nbbj
From the Office of
NBBJ
223 Yale Avenue North
Seattle, WA 98109

ADDENDUM NO. 01
July 10, 2014

M2.00-DPW

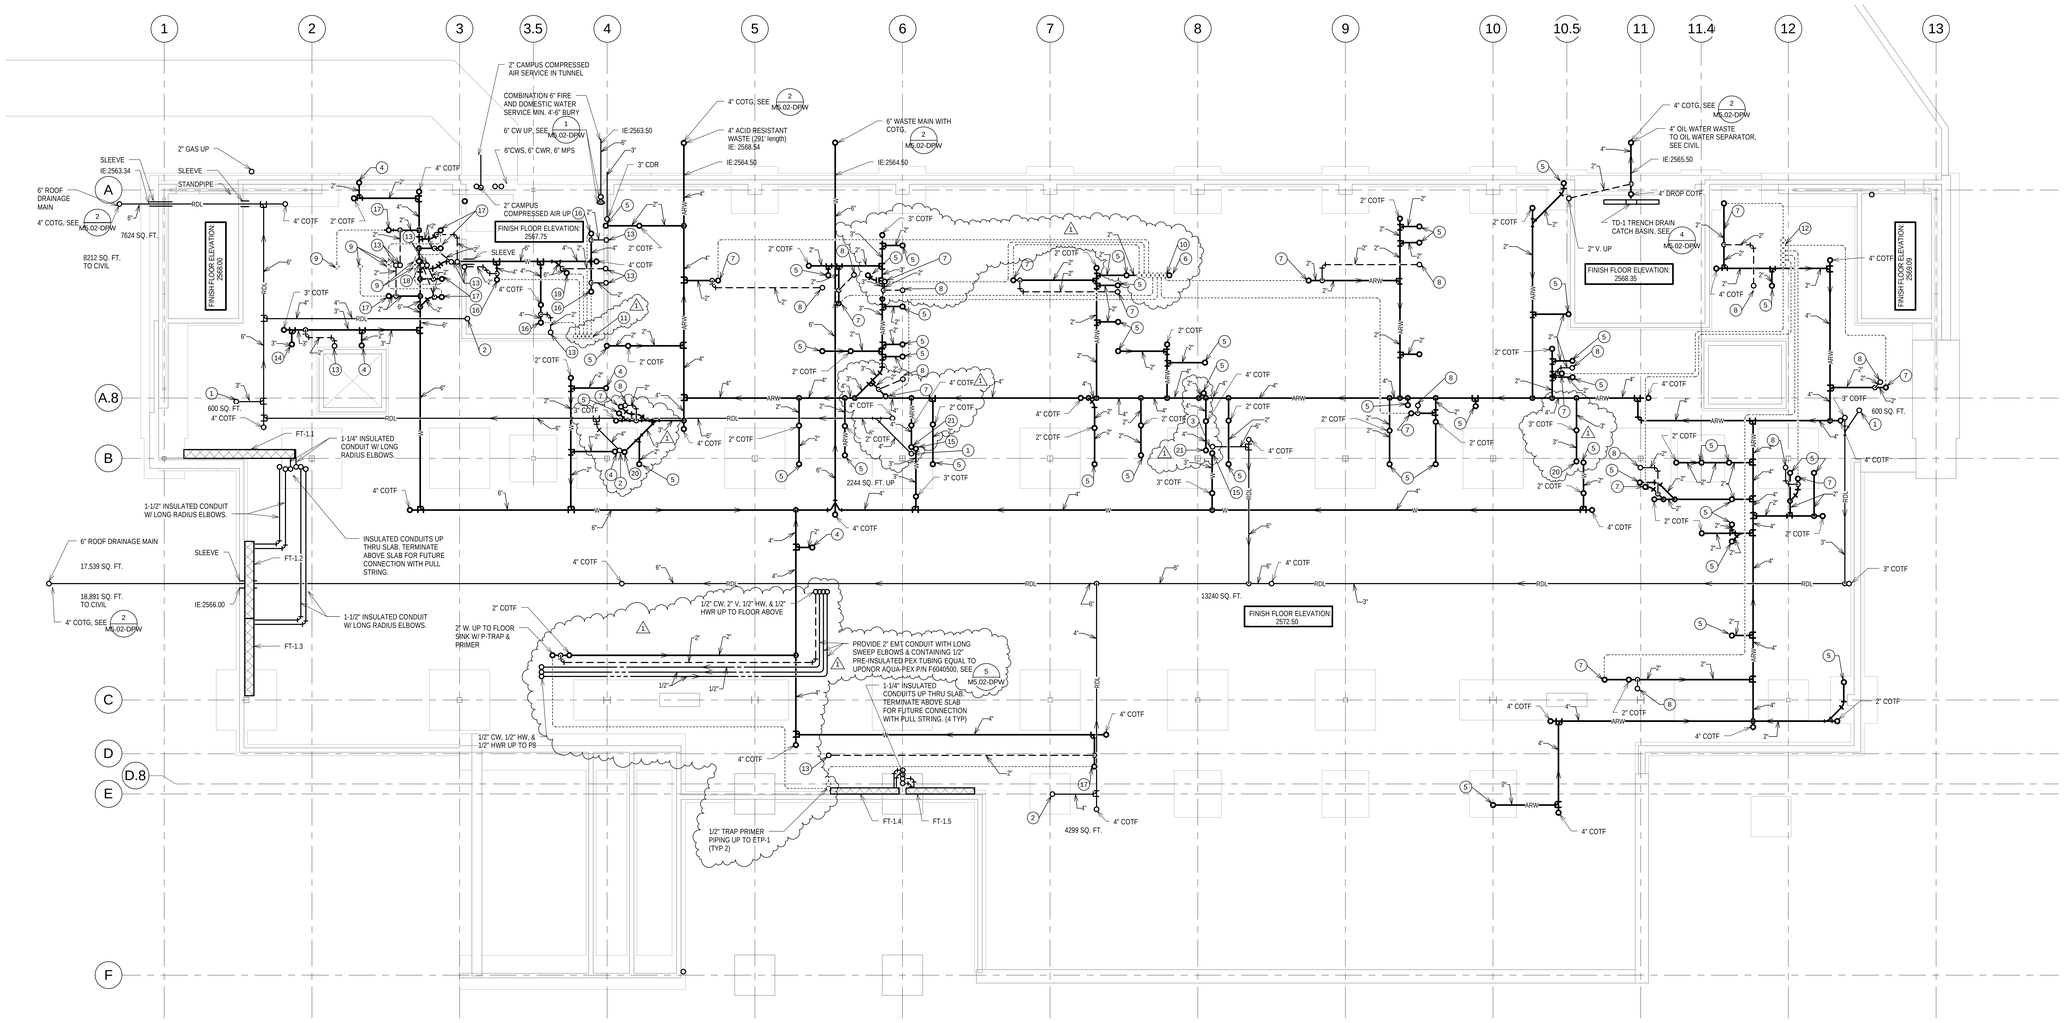
a. ***ADD*** trap primer piping to connect to Floor Sink trap at Grids 3.7/C.2. Route piping as indicated on attached drawing to location of 1/2" up to ETP-1. Change note to read (TYP-2).

b. ***CHANGE*** (3) under slab water pipes (1/2"CW, 1/2"HW and 1/2"HWR from copper Type "K" piping to 1/2" pre-insulated PEX piping contained within 2" EMT metal conduit with long-sweep elbows each as indicated on attached drawing and detailed as detail 5 on attached drawing M5.02-DPW.

c. ***REVISE*** sizing of ARW mains from main riser stacks in four (4) locations, as indicated on attached drawing. The four locations and sizes are as follows: (2) 3" ARW at Grid B with (1) between Grids 10.5 and 11 heading North to approximately Grid A.8 and (1) starting at Grid 4.2 and heading Northeast to approximately Grid A.9. Additional (2) 4" ARW at Grid B with (1) starting at Grid 6.1 heading North to approximately Grid A.8 and (1) starting at Grid 8.1 and heading Northeast to approximately Grid A.8.

d. ***RELOCATE*** 2" ARW up to 2" Floor Sink Type 1 located at Grids A.8/5.9 to the West 4", see attached drawing.
   e. ***PROVIDE*** new 2" Floor Sink Type 1 with 2" ARW with 2" ARV at Grids A.4/5.8 including 1/2" trap primer piping from electronic trap primer at Grids A.3/7.7. Provide for 2" ARV to proceed to above floor at location indicated on attached drawing.

f. ***REVISE*** key note "10" located at Grids A.4/4,1 to read 11. As indicated on attached drawing.
   g. ***REVISE*** key note number "10" to read (TYP-7) and key note number 11 to read (TYP-5). As indicated on attached drawing.

h. ***ADD*** key note number "21" to read, 4"ARW UP, as indicated on attached drawing.
6. M2.01-DPW – FIRST FLOOR PLAN – MECHANICAL
   a. ***RELOCATE*** 2" Floor Sink Type at Grids A.8/5.9 to the West 4", see attached drawing for new location.

M2.01-DPW

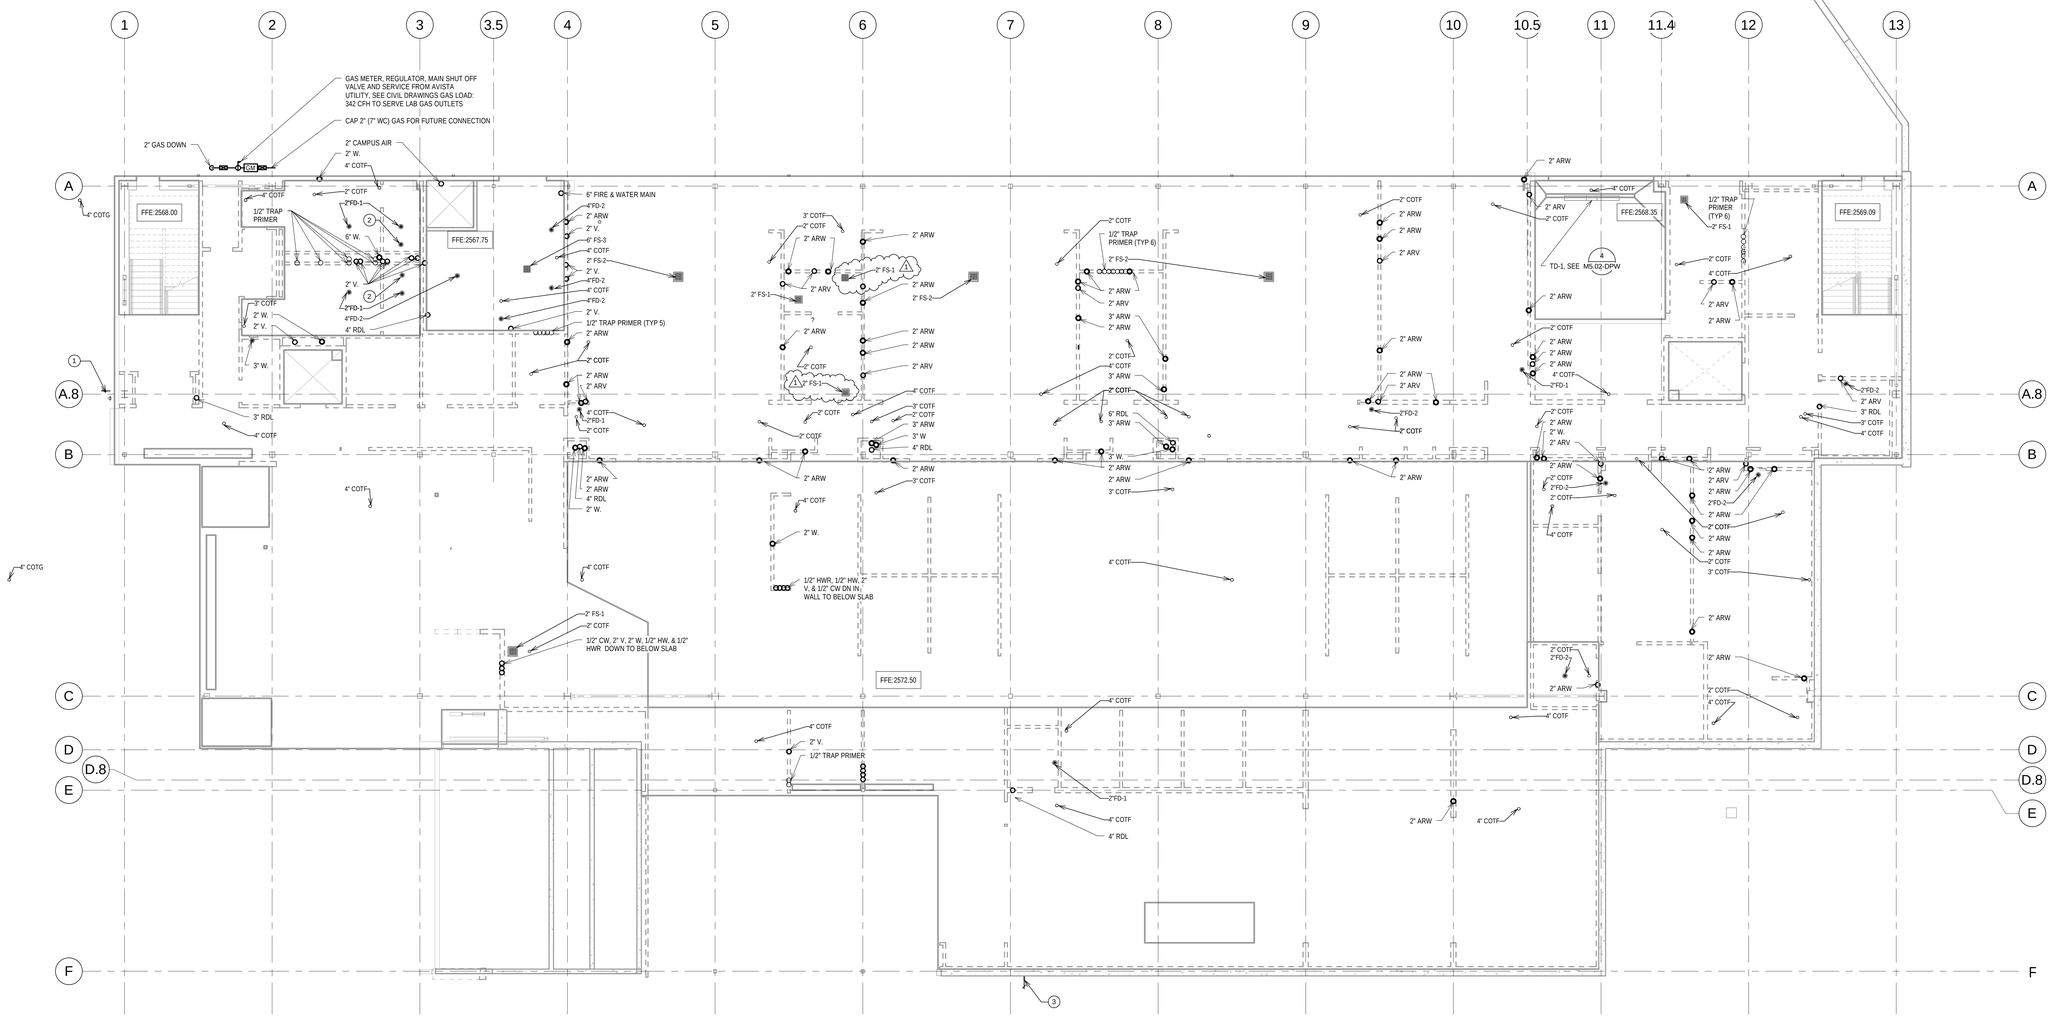
b. ***PROVIDE*** new 2" Floor Sink Type 1 located at Grids A.4/5.8 as indicated on attached drawing.
7. M2.02-DPW – SECOND FLOOR PLAN – MECHANICAL
   a. ***RELOCATE*** block-out for 2" Floor Sink Type at Grids A.8/6.4 to the West 15", see attached drawing for new location.

M2.02-DPW

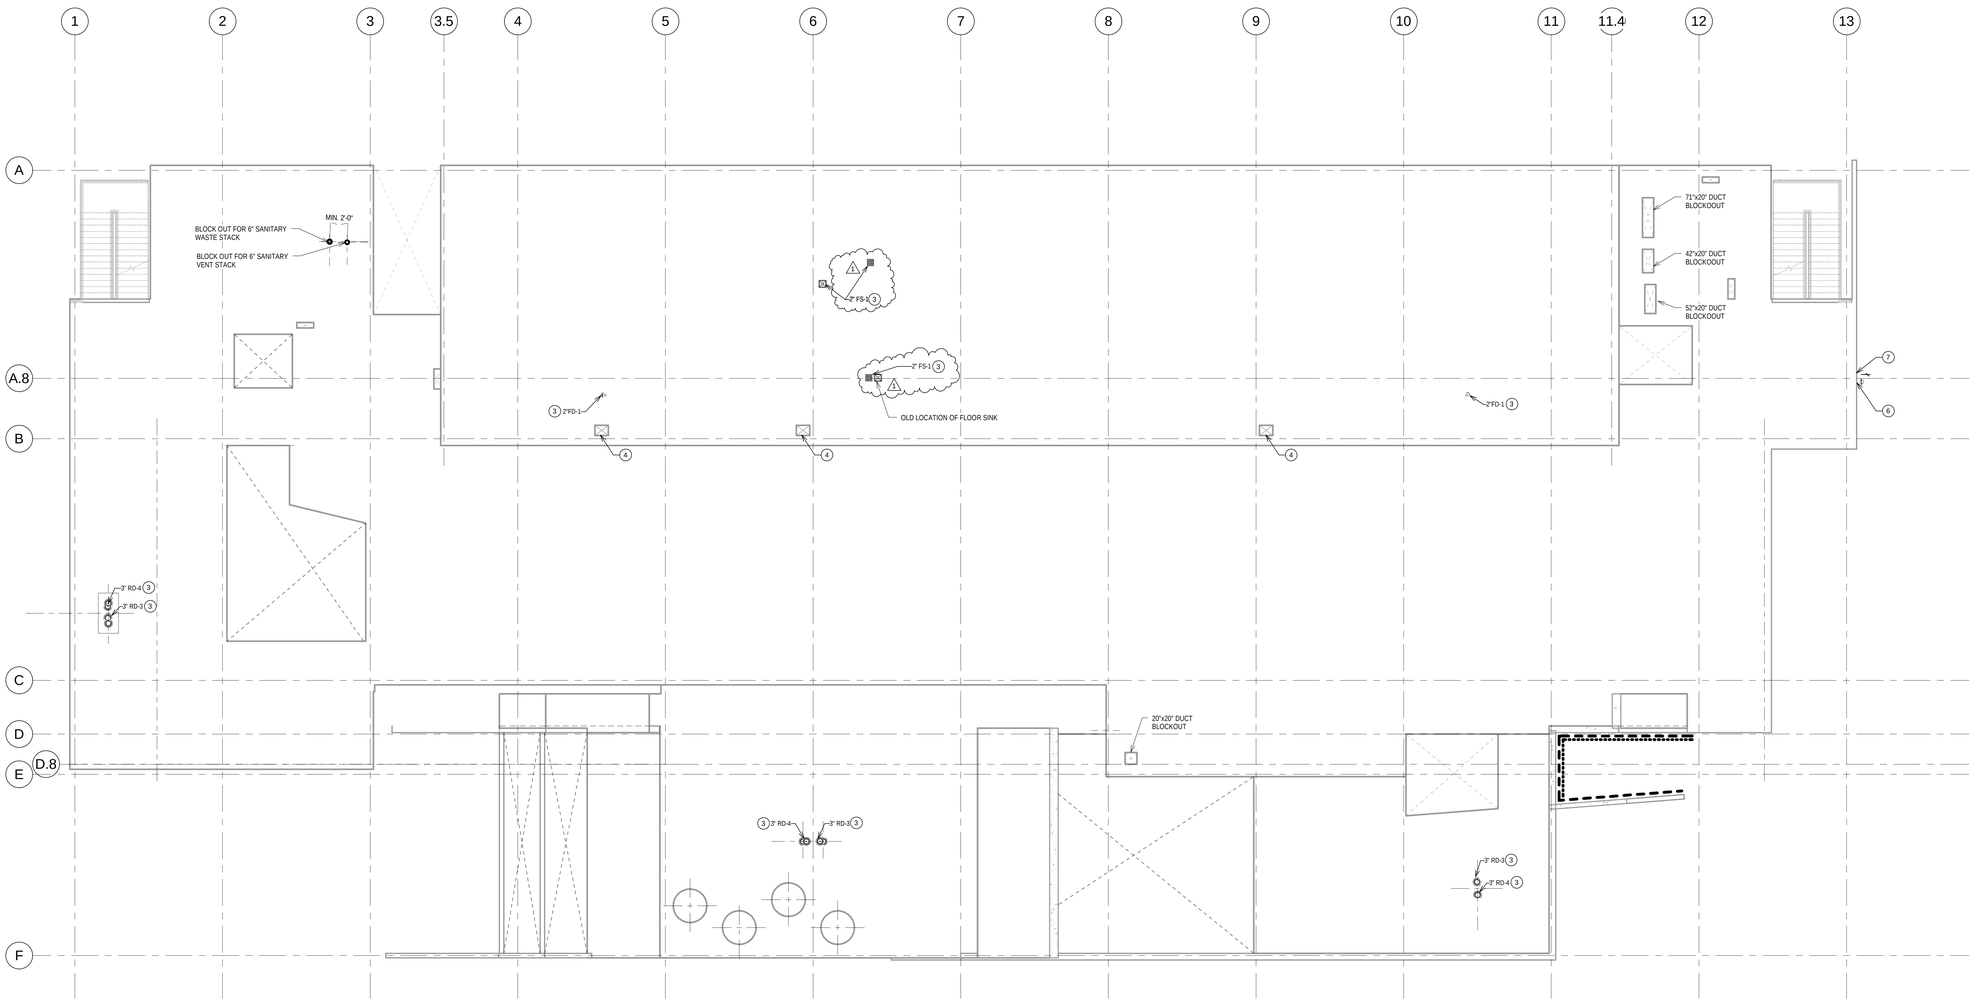
b. ***PROVIDE*** block-out for new 2" Floor Sink Type 1 located at Grids A.4/6.4 as indicated on attached drawing.

M2.03-DPW

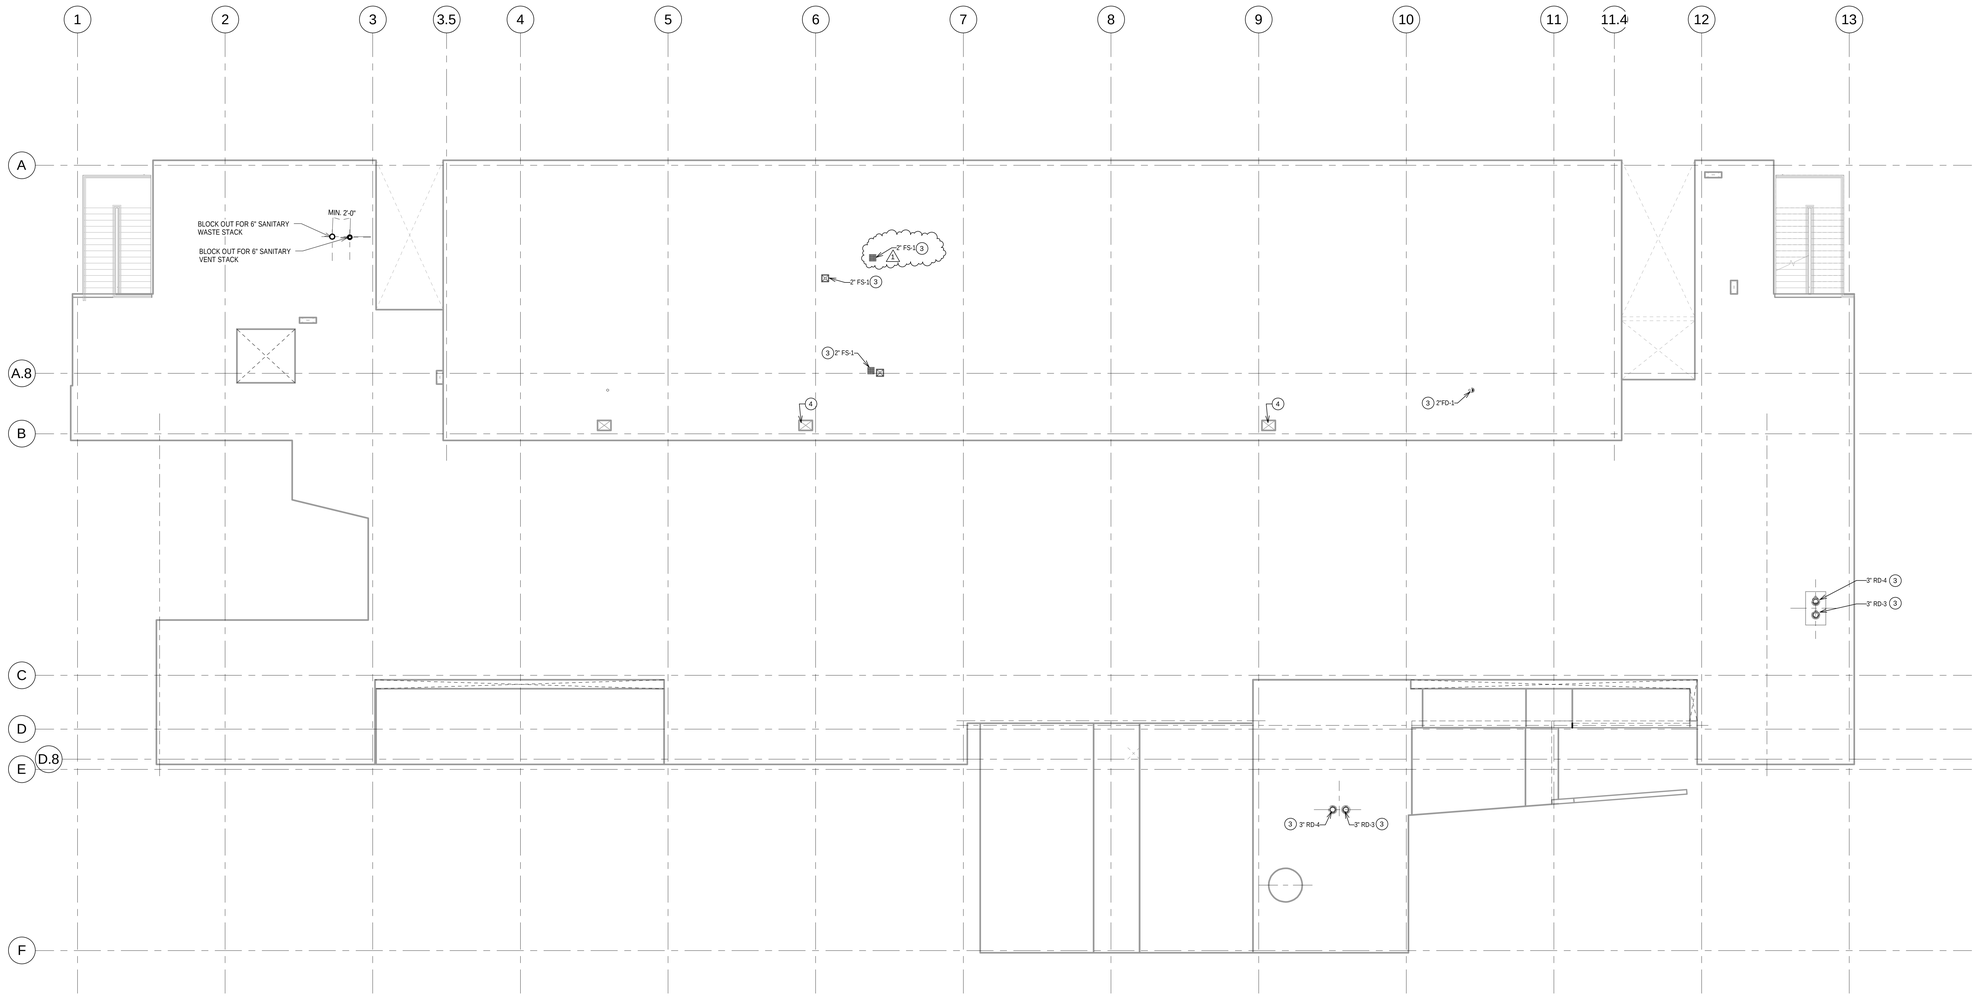
8. M2.03-DPW – THIRD FLOOR PLAN – MECHANICAL
   a. ***PROVIDE*** block-out for new 2" Floor Sink Type 1 located at Grids A.4/6.4 as indicated on attached drawing.
9. M5.02-DPW – DETAILS – MECHANICAL
   a. ***ADD*** detail 5 to indicate 2" EMT metal conduit with long-sweep elbows to contain pre-insulated PEX tubing see attached drawing.
